# Receiver sensitivity proposed changes

IEEE P802.3cd interim, Geneva, Switzerland, January 2018

# Proposal for 140

Figure 140-4—Illustration of receiver sensitivity

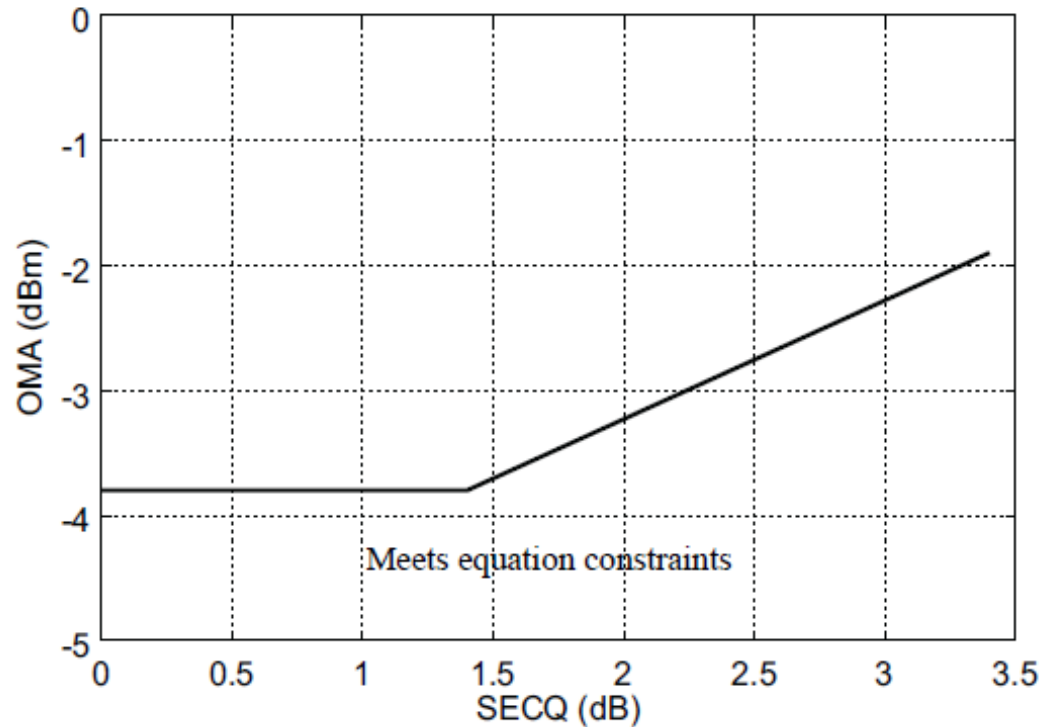
# Full changes to 140.7.8

## 140.7.8 Receiver sensitivity

Receiver sensitivity is informative and is defined for a transmitter with a value of SECQ up to 3.4 dB. Receiver sensitivity should meet Equation 140-1, and is illustrated in Figure 140-4.

$$RS = \max(-3.9, SECQ - 5.3) \quad (\text{dB}) \quad (140-1)$$

where

$RS$  is the receiver sensitivity

$SECQ$  is the SECQ of the transmitter used to measure the receiver sensitivity

The normative requirement for receivers is stressed receiver sensitivity.
